Title - Sujet Building Modernization - Phase 2	
Solicitation No. - N° de l'invitation EC015-140977/A	Amendment No. - N° modif. 003
Client Reference No. - N° de référence du client R.039554.001	Date 2013-09-13
GETS Reference No. - N° de référence de SEAG PW-\$PWB-020-3297	
File No. - N° de dossier PWB-3-36036 (020)	CCC No./N° CCC - FMS No./N° VME
Solicitation Closes - L'invitation prend fin at - à 02:00 PM on - le 2013-09-24	Time Zone Fuseau horaire Atlantic Daylight Saving Time ADT
F.O.B. - F.A.B. Plant-Usine: <input type="checkbox"/> Destination: <input type="checkbox"/> Other-Autre: <input type="checkbox"/>	
Address Enquiries to: - Adresser toutes questions à: Donovan, Janine PWB	Buyer Id - Id de l'acheteur pwb020
Telephone No. - N° de téléphone (506) 636-5347 ()	FAX No. - N° de FAX (506) 636-4376
Destination - of Goods, Services, and Construction: Destination - des biens, services et construction:

This Tender Amendment No. Three (3) is raised to include the following Addendum No. Three (3).

Addendum No. 3.

.5 Reference Drawing E-103:

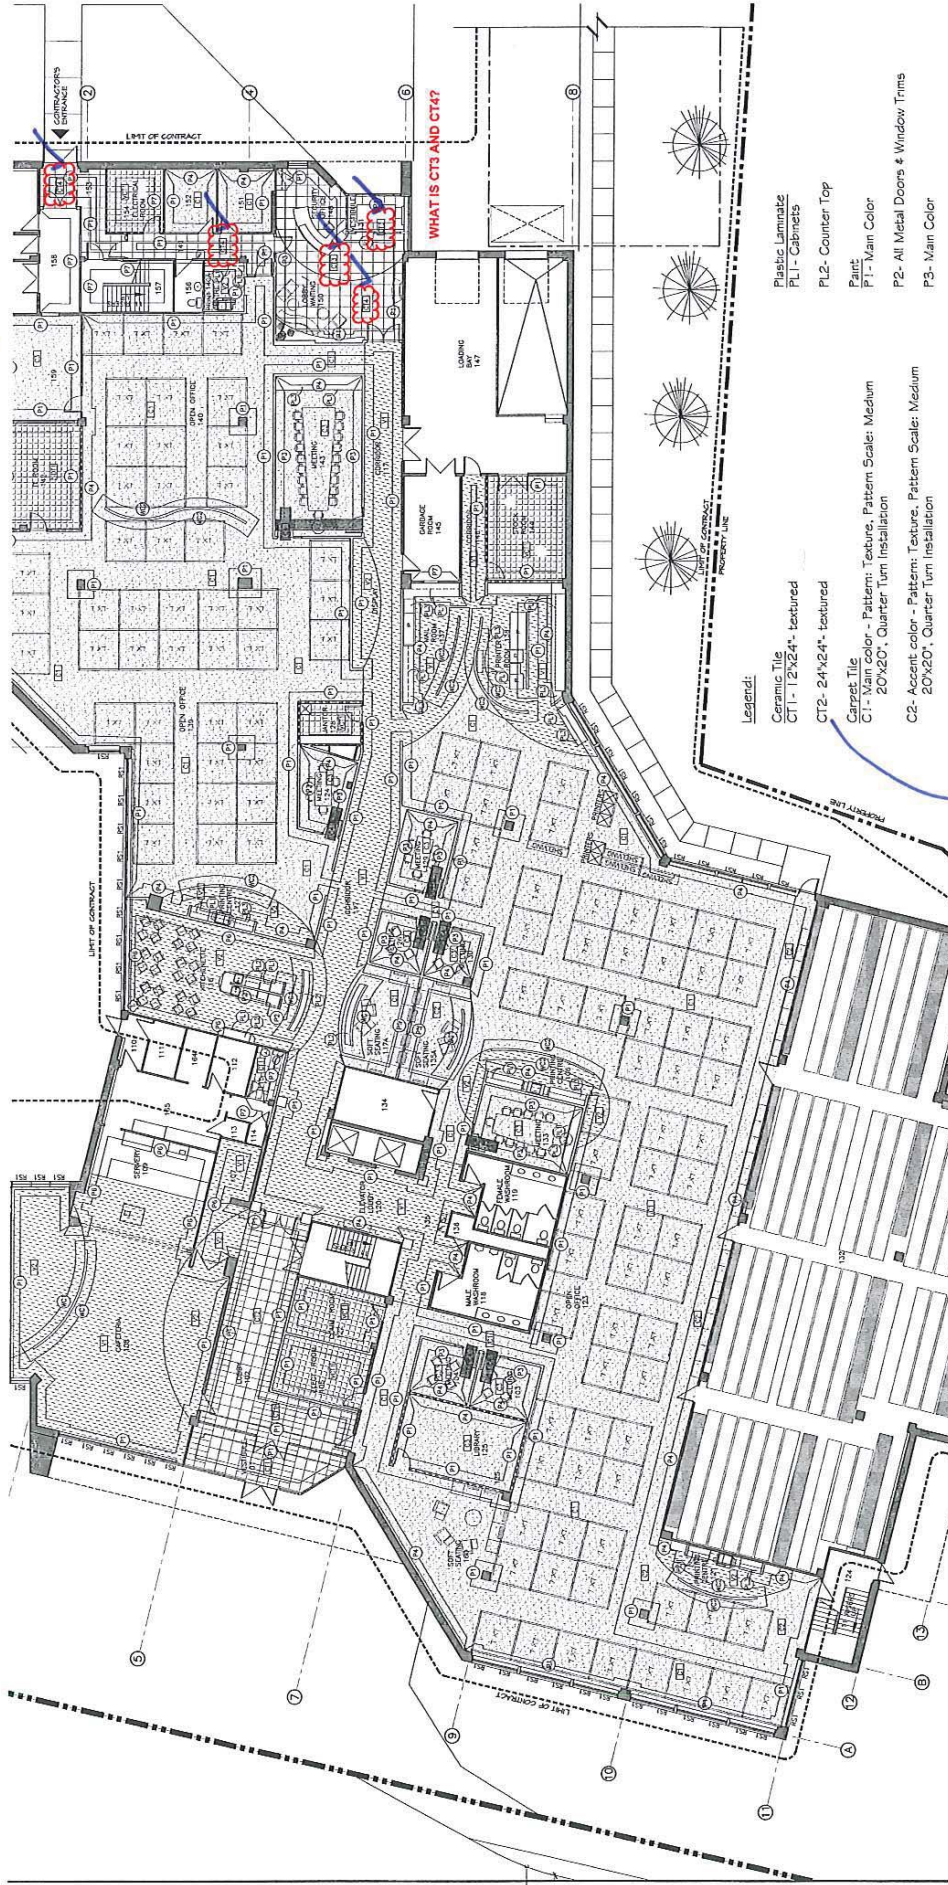
.1 The detectors in room 132 are to be connected to the pre-action system to system activation. Make connections to the pre-action system between the detectors and the fire alarm panel to provide operation of the pre-action system as intended.

A903 - Mark up

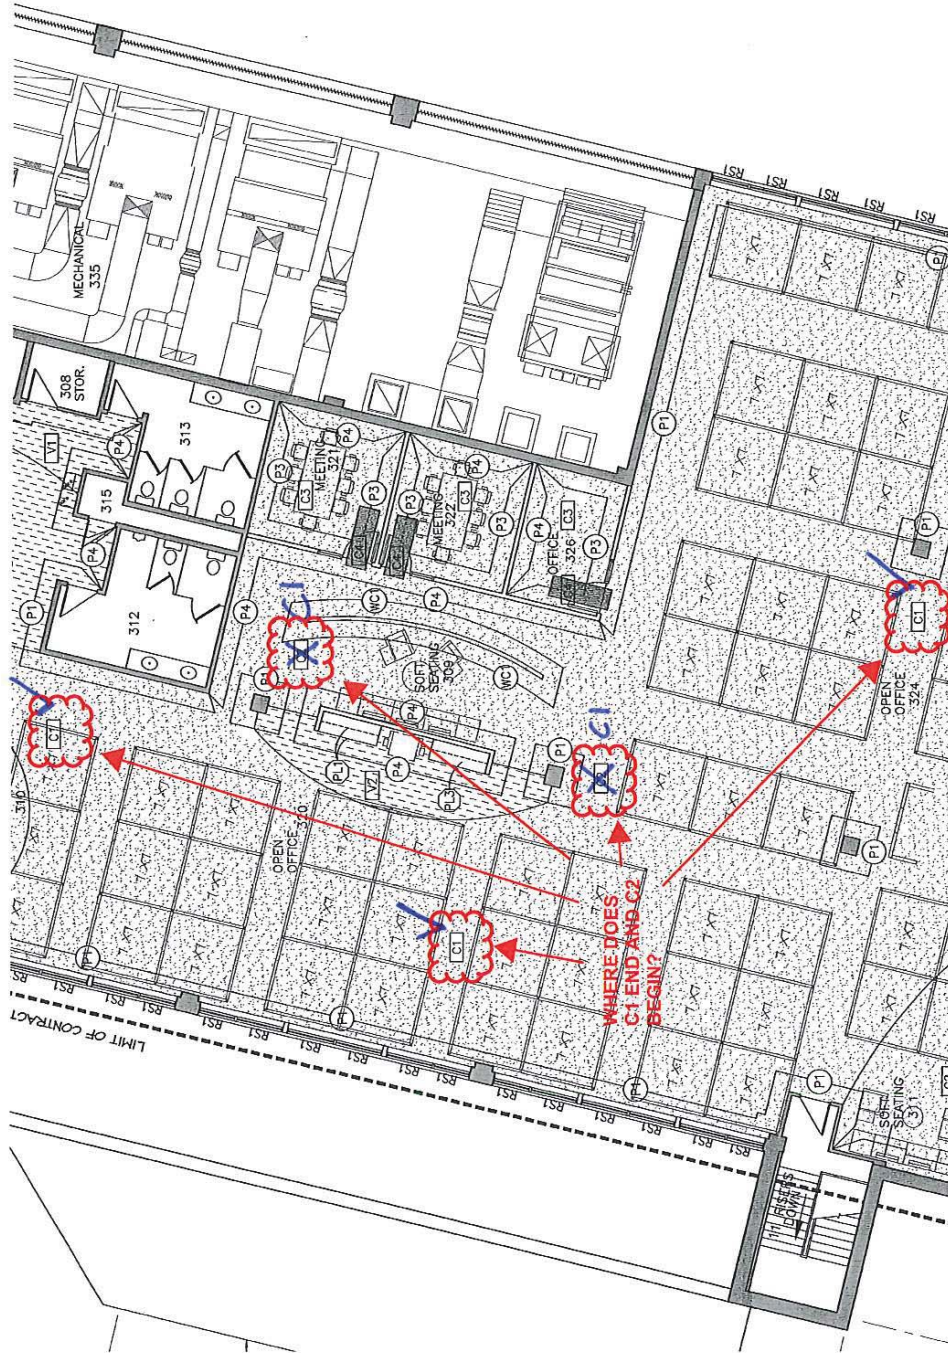
Q1. I noticed some discrepancies between the finish schedule on A-901 versus the interior finish plans A-902 and A-903. I have marked them up in red accordingly for easy reference. Can you provide some clarification?

A1. Refer to sketches ASK-1, ASK-2 and ASK-3 (Attached).
